MEMORANDUM

RE: Building Box Reconfiguration – Lot 7 Steeple View Estates (1145 RFD)

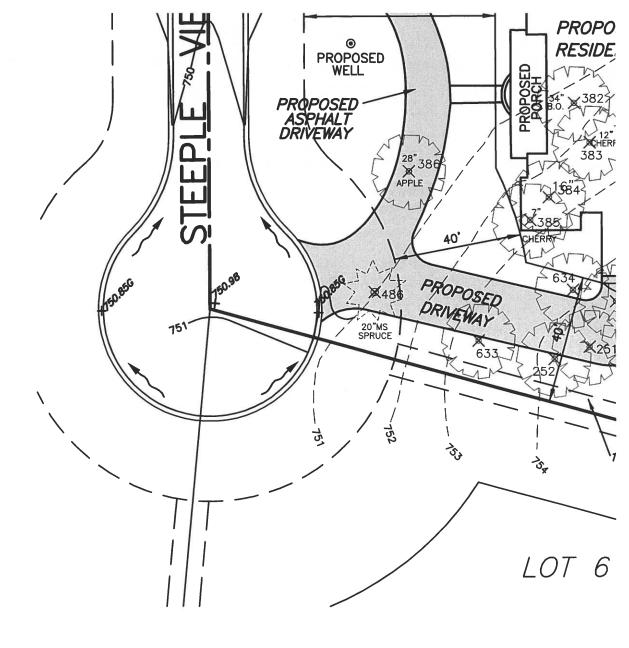
Although the boundaries of the building box could be altered it appears the building box is being expanded; not just a reconfigured.

Stormwater is a concern, wetland preservation was also an issue with this approval; not sure if the alteration impacts any of this or not; I have contacted the Village Engineer regarding any stormwater issues.

If a private septic will service the property, septic placement may also be a consideration.

Impacts to existing trees per the tree preservation ordinance and in particular protected tree species is a concern as was so with the PUD approval.

- The building box has not grown but only reconfigured. We have moved the rear property line further North to accommodate the push outward West. The proposed new building box is 12,190 sf, which is equal to the previous building box size. Please see the attached proposed engineering conceptual site plan.

- Stormwater runoff should not be affected by this building box change. There are two existing stormwater structures on the East property line that will collect stormwater runoff. We are not proposing a change to this design.

- Please see the proposed septic plan with the new proposed location.
- 9. "Impacts to existing trees per the tree preservation ordinance and in particular protected tree species is a concern as was so with the PUD approval."

- Acknowledged. Please see the proposed tree removal exhibit.

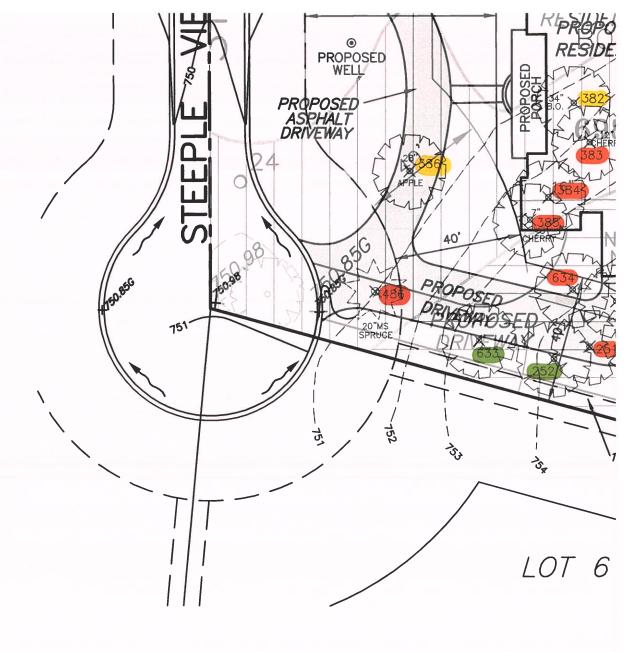
I reviewed the existing site conditions and Concept Plan by Heritage Land Consultants, LLC, dated 3-15-21, for a new single family residence at 1145 Steeple View Drive. The following are my observations and recommendations.

- 2. There is an untagged 12", 12" black walnut in fair/good condition located near tree #381 that has not been shown on the plan or inventory listing, as well as an untagged 8" black cherry in fair condition near tree #258. These trees are considered protected trees by the ordinance requirements and will require mitigation.

- 3. The concept plans do not show any tree protection/silt fencing or proposed grading and utilities. The inventory listing shows tree #'s 194, 195, 199, 201, 203, 206, 209, 252 and 633 being preserved but several of these will have their critical root zones significantly impacted by the septic field and driveway. Tree #'s 633 and 252 are located right on the edge of the driveway. Excavating for the driveway right next to the trunk will sever structural roots and make these trees hazardous. Several of these trees are protected trees and mitigation will be required if they are significantly impacted.

The applicant should submit a site development plan that shows the construction envelope with tree protection/silt fencing located at the limits of disturbance, existing/proposed grades and any proposed utilities. Once these plans have been submitted, I will be able to determine the mitigation requirements for the protected trees being impacted and/or removed for this development.
